Town of Parker Community Development Department
 Development Review Division
 Attention: **Julia Duncan**

Application Type: **Subdivision Plan – Replat**
 Status: **First Referral**
 Application Name: Compark Village South
 Case/AP#: **SP-118**
 Referral Received: October 14, 2021
 Comments Due: November 15, 2021

Review date: **November 8, 2021**
 Plan reviewer: **Randall L. Capra**, rcapra@parkeronline.org
 Phone: 303.805.3168

TOWN OF PARKER - FIRE/LIFE SAFETY:	C REVIEWED FOR CODE COMPLIANCE w/COMMENTS
---	--

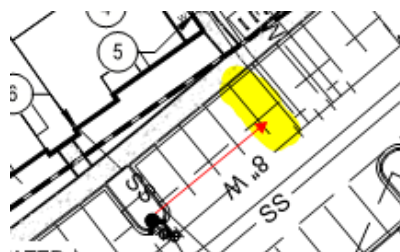
11. The overall utility plan shall identify each underground fire line (UFL) by name length and size (as measured from the "T" in the access road to the flange within the building); see below for an example and address when resubmitting. *Not satisfied; the applicant has indicated that the Water and Sanitary Plans are to be provided with*

the resubmittal of the SUB21-065; to ensure that the site meets the requirements and that all applications are consistent and correct, the utility drawings will be provided with all applications specific to this project. Address this issue when resubmitting. **Not satisfied; applicant has indicated that the notations have been provided without providing a plan set to verify. This issue must be addressed prior to sign/stamp of this document by this office. Not satisfied; applicant has provided a utility drawing that indicates the location of the UFL (thank you) though the diameter and the length of the UFL, as measured from the T to the flange in the building has not been noted on the utility plan. Address this issue when resubmitting.** Not satisfied: applicant has not provided the diameter and length for each UFL, as measured from the T to the flange in the building, as required. This should be shown as a measurement for each building... not a note somewhere on the plan set. Note – See below what an example of what is required should look like... size and diameter are only numbers used for this scenario on Bldg 8: **Satisfied; applicant has addressed with the sixth submittal**

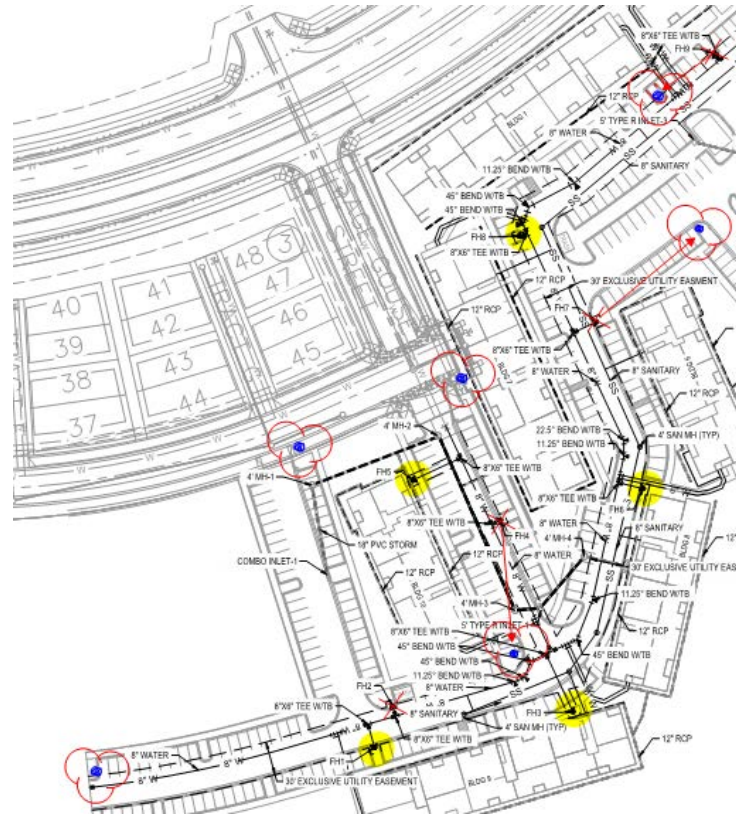
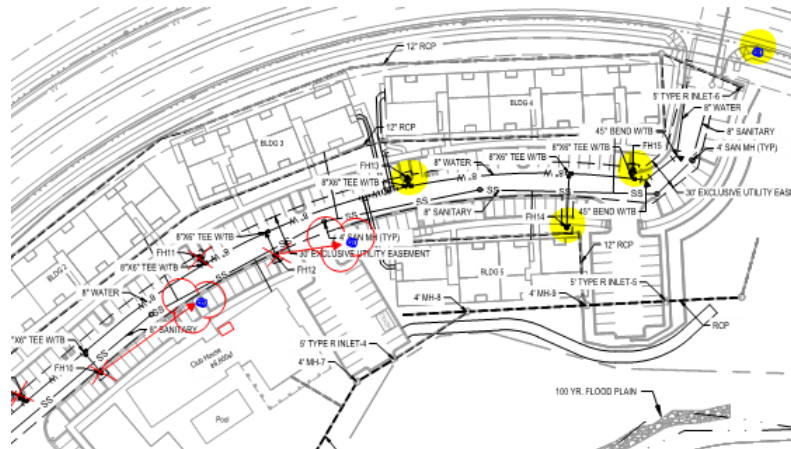
13. The hydrant distribution has been redlined to accommodate response more effectively; the overall utility drawing shall include the hydrant distribution for all filings and the following criteria. See below for information on hydrant location criteria and on revisions to the hydrant layout (hydrants have been deleted, added, and relocated while shown at entry ways if not currently addressed): **Partially satisfied; applicant has noted/ acknowledged/addressed with current submittal though a fire hydrant is still required at the eastern intersection of Belford Ave and Deer Track Drive and a hydrant is required at the "T" of Deer Track Lane and Wolf Fox Street (also shown as Bunny Hop Lane... this issue should be addressed with the next submittal, as well) and relocate the fire hydrant in front of building 1. This hydrant is located in the island west of the east end of the building. The island shall be moved over 5 parking spots to align this hydrant between both building 1 and building 2 (as fire hydrants should be within 40 feet of the building to be served). Address these issues when resubmitting: Satisfied; applicant has acknowledged with current submittal**

- Hydrants shall be located no further than 40 feet of the building to be served.
- Hydrants serving buildings with fire suppression systems shall be located in the general area of the riser room.
- Divided roadways require that hydrants be spaced at 250 foot intervals on a stagger (on each side of the road); these hydrants shall be located 500 feet apart on each respective side of the road.
- Hydrants shall be located at the entry into each sub area.
- Hydrants shall be located at the end of most cul-de-sacs.
- Hydrants shall be located at the corners of all streets where possible
- Hydrant spacing shall meet the requirements of the 2018 IFC Chapter 5 and appendix B and C
